# CITY OF LONG BEACH

Receive report and provide direction to staff on the options addressing biotechnical and various other alternatives for the Ocean Boulevard (Bluff) Erosion and Enhancement Phase 2 Project. (District 3)

**PEER REVIEW REPORT  
OCEAN BOULEVARD EROSION AND ENHANCEMENT  
PHASE 2 PROJECT  
CITY OF LONG BEACH, CALIFORNIA**

June 23, 2014

Figure 1 - Design Cross-Section of Soil Nailing

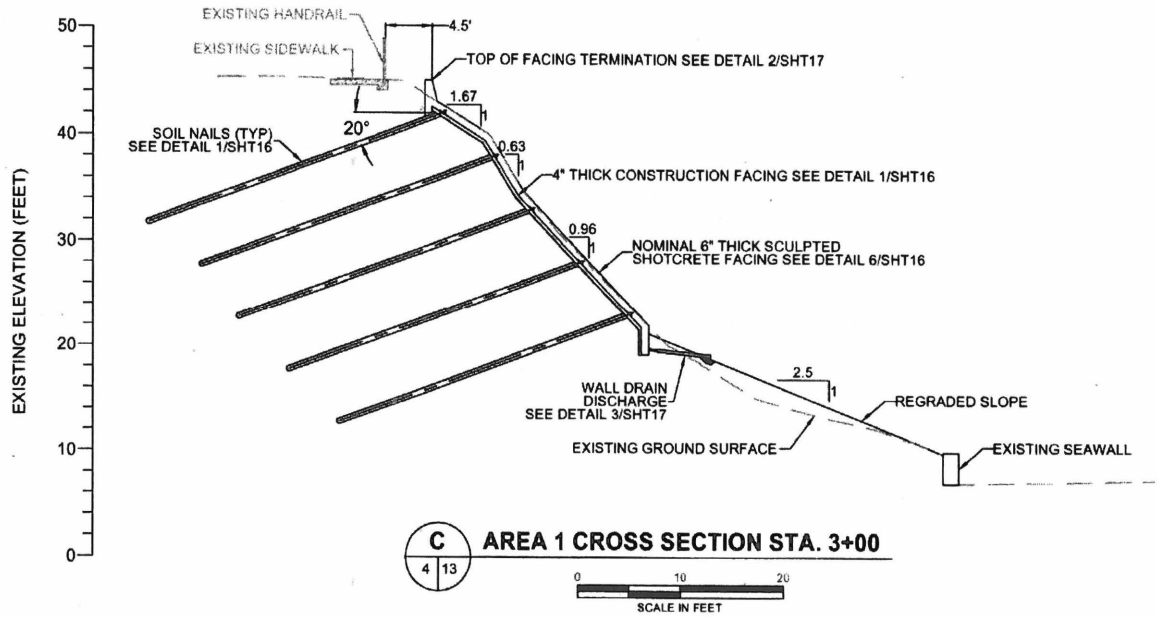
- Soil nails that enhance the deep-seated stability of the bluff under static and dynamic conditions (Figure 1) and locally support portions of the sidewalk; and
- A shotcrete facing (Figure 1) that protects the slope surface from weathering and erosion caused by surface water, and enhances the surficial stability.

The shotcrete facing will be sculpted to blend in with the surrounding landscape. At specific locations, the shotcrete facing has planter pockets that allow vegetation to grow on the slope and with time will partially cover the shotcrete surface, as exemplified in Figure 2. The design contemplates having open-bottom planters that allow infiltration into the slope. Failure of sprinklers and/or the irrigation pipes may result in a concentrated influx of water directly into the slope which is undesirable. The design includes irrigation PVC pipes embedded into the shotcrete to drain excess irrigation water.

Soil nailing with shotcrete facing is commonly used in southern California for bluff stabilization. Examples of successful bluff stabilization projects include the Del Mar Bluffs Stabilization and Pacific Coast Highway Bluff Stabilization in Dana Point and San Clemente.

It is the Committee’s opinion that the recommendations on using soil nailing with shotcrete facing is reasonable considering the project parameters discussed in Section 2.1. An available alternative to shotcrete for slope face protection is using biotechnical techniques as discussed later in Section 3.0.

Figure 3 – Example of Deep-Rooted Vegetation

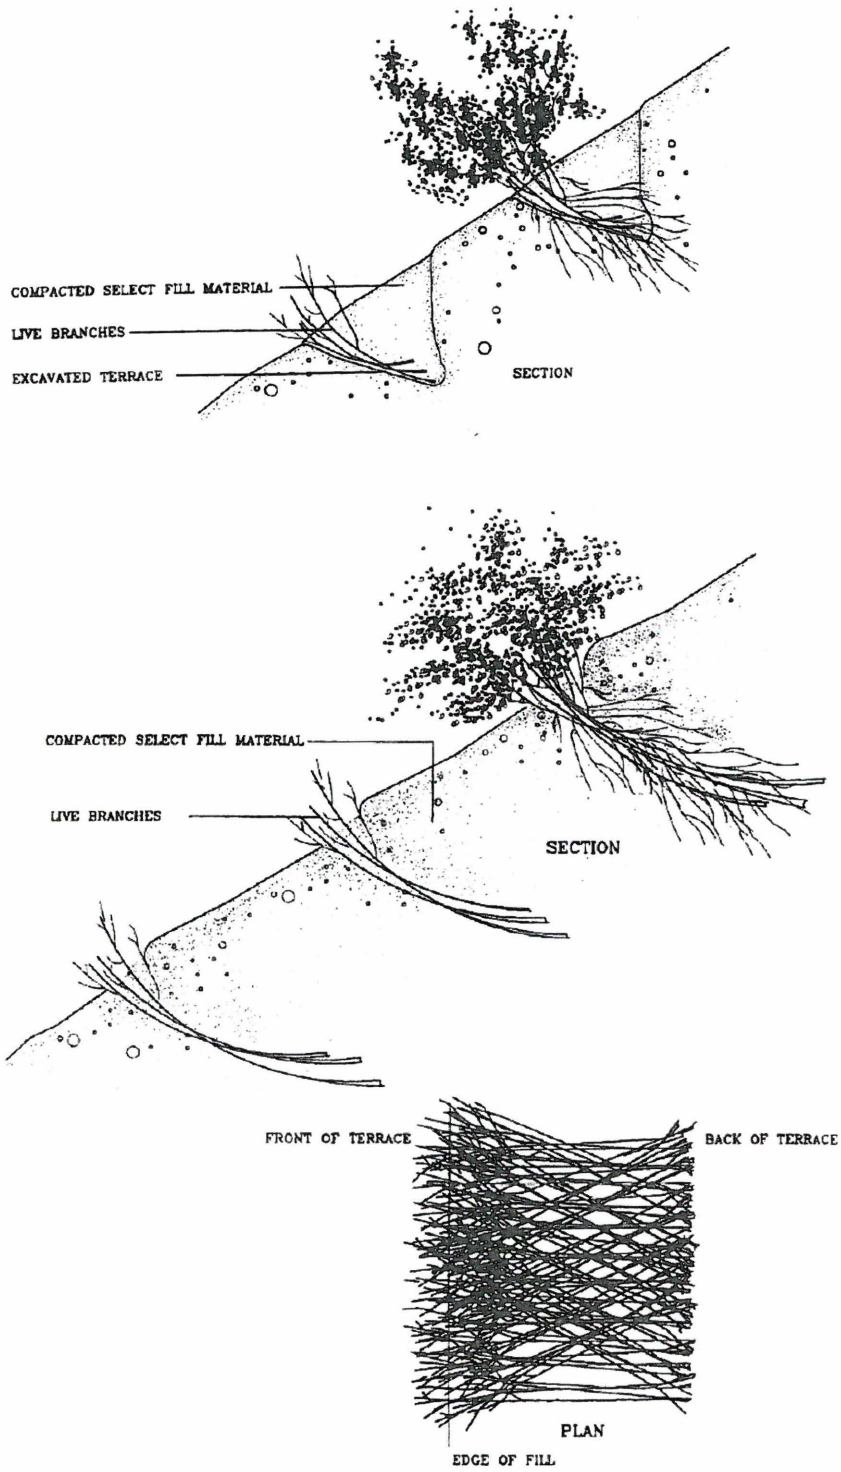
- Deep rooted vegetation as depicted in Figure 3;
- Deep rooted vegetation in combination with geogrid or timber grid used to hold topsoil and slope plantings as shown in Figure 4; and
- Live slope grating where a lattice-like array of vertical and horizontal timbers are fastened or anchored to a steep slope and the openings in the structure are filled with suitable backfill material and layers of live branch cuttings (see Figure 5).

These biotechnical techniques could be considered for the subject slope instead of shotcrete, especially for slope inclinations of 1:1 or flatter. Although biotechnical techniques generally provide excellent erosion protection, the resulting vegetation requires significant maintenance. Biotechnical techniques only improve the stability of the near-surface soils and provide a very limited benefit for deep-seated instabilities; thus, they are not a substitute to soil nails as their depth of influence is limited.

These techniques can be used in the western portion of the project, designated as Area 1 and the western portion of Area 2 on the Construction Plans, where the slope has been stabilized with soil nails but shotcrete has not been installed. Area 1 has slope inclinations varying from 0.63:1 to 1.63:1 (horizontal:vertical) from top to bottom of the slope, which would make the installation of a geogrid or steel mesh facing easier to implement than timber grid or timber grating. Deep-rooted vegetation may be used for the flatter inclination, perhaps in combination with shotcrete or geogrid/steel mesh for the steeper slopes. The western portion of Area 2 has a fairly uniform inclination of 0.85:1 to 1:1 (horizontal:vertical) that can facilitate the biotechnical options mentioned above. Minor grading may be required to create a bench to support the timber grids or grating. Due to steepness and variety of inclinations of the slope, biotechnical
